January 24, 2018

RE: Comment Response for Front Range-Midway Solar Project, LLC Application for a Wind/Solar Energy Generation Overlay (WSEO), Submittal #1,

EL PASO COUNTY PLANNING AND COMMUNITY DEVELOPMENT DEPARTMENT

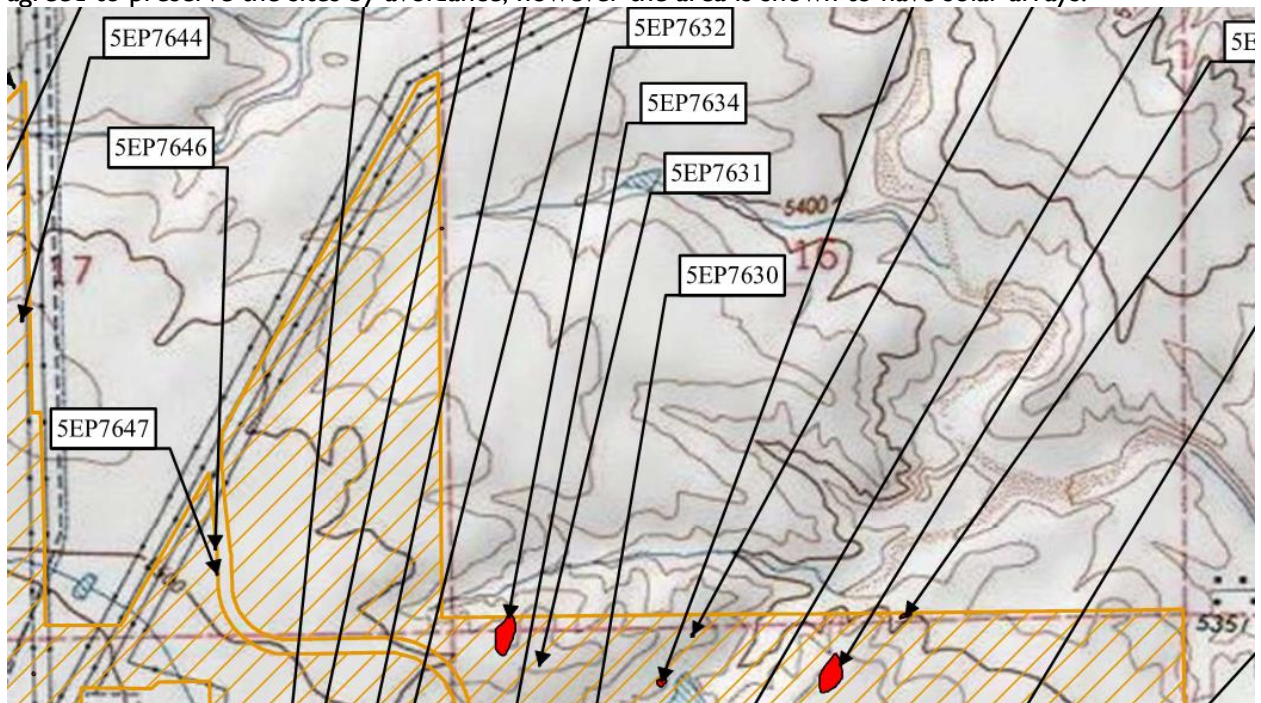
- I. Two class III cultural sites (prehistoric) were identified within the project boundary area. [lithic reduction locale, surface assemblage is fragmented- moderate potential for buried cultural materials] The State Historic Preservation Officer (SHPO) and [Front Range-]Midway Solar have agreed to preserve the sites by avoidance; however the area is shown to have solar arrays.

Identified sites to be avoided

Applicant is showing solar arrays on site

2. The sites (5EP7625 and 5EP7632) identified in the September 2016 final environmental assessment are located at the northern portion of the property east of La Questa as depicted above. A letter from the SHPO has been provided. If avoidance cannot be adhered to further excavation would be necessary, please provide further documentation.

Response: Preliminary design has been updated to avoid the potential archeological sites identified in the Class III Cultural Resources Inventory and recommended for avoidance. Please see updated Site Plan (Attachment M), which depicts avoidance of archeological sites. All other Attachments show avoidance of these sites, including the WSEO Plan.
